ITEM: 60-87 CHAPARREL PUD - Preliminary

The City Staff has completed its review of Chaparral P.U.D.-Preliminary, and has the following comments:

Re: Chaparral P.U.D., Preliminary submittal

The City Staff has completed its review of Chaparral PUD, Final, and has the following comments:

STAGE-STORAGE CURVE
OPTION 1 - BLOCK 2, 20 LOTS

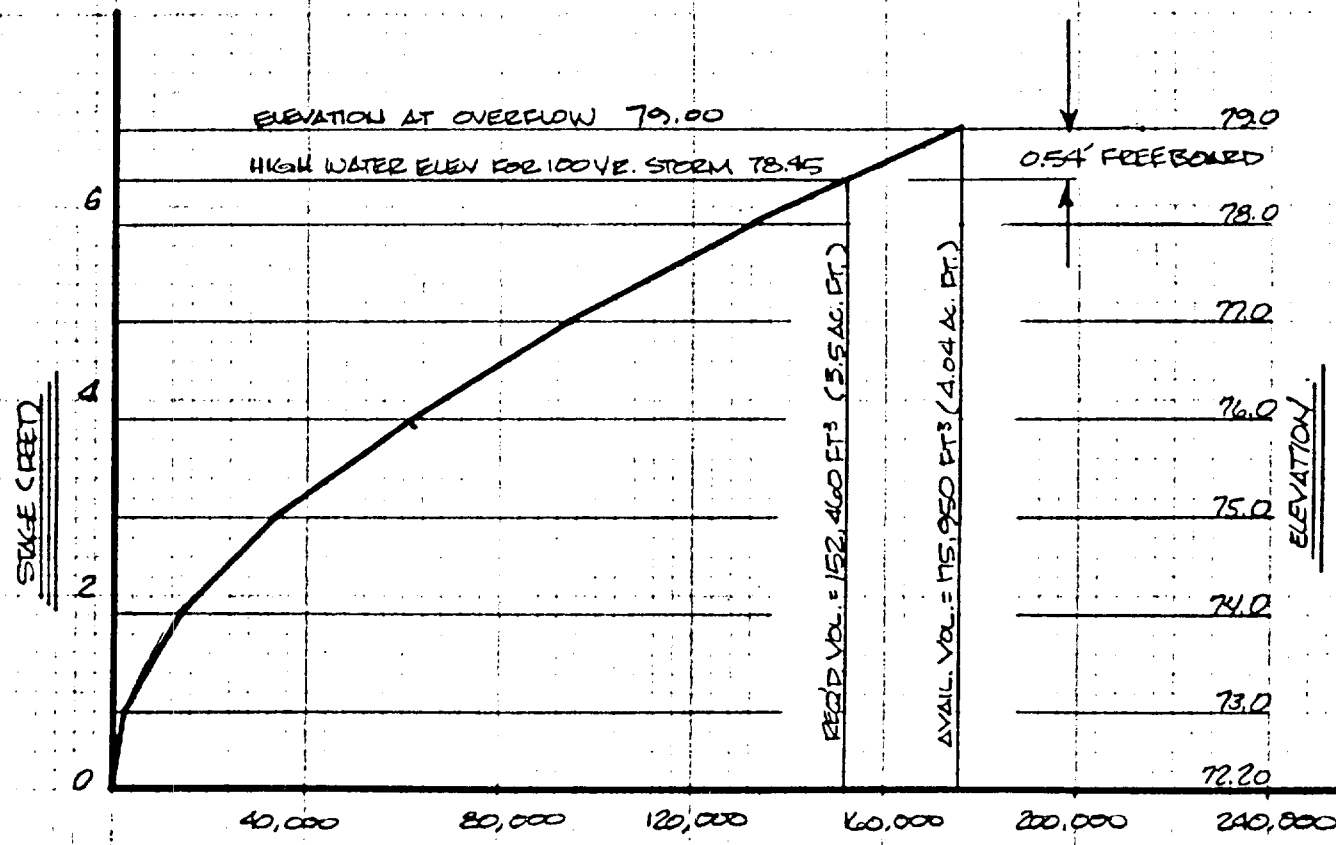
15. Curvilinear storm sewers are not allowed.
16. Proposed contours need to be shown in the proposed detention pond to verify if the detention volume can be obtained as well as provide required freeboard. Also the bottom slope of the detention pond is to be a minimum of 2% unless paved in which case the slope may be reduced to 1% and side slopes are not to be steeper than 4:1.

16. The requested information has been added to the Grading and Drainage plan, and is included in the attached exhibits. It should be noted that we anticipate being able to provide approximately 0.5 feet of freeboard, as shown in the attached exhibits. It is understood that at time of final submittal, we will detail the hydraulic grade line, as requested by Glen Schlueter.
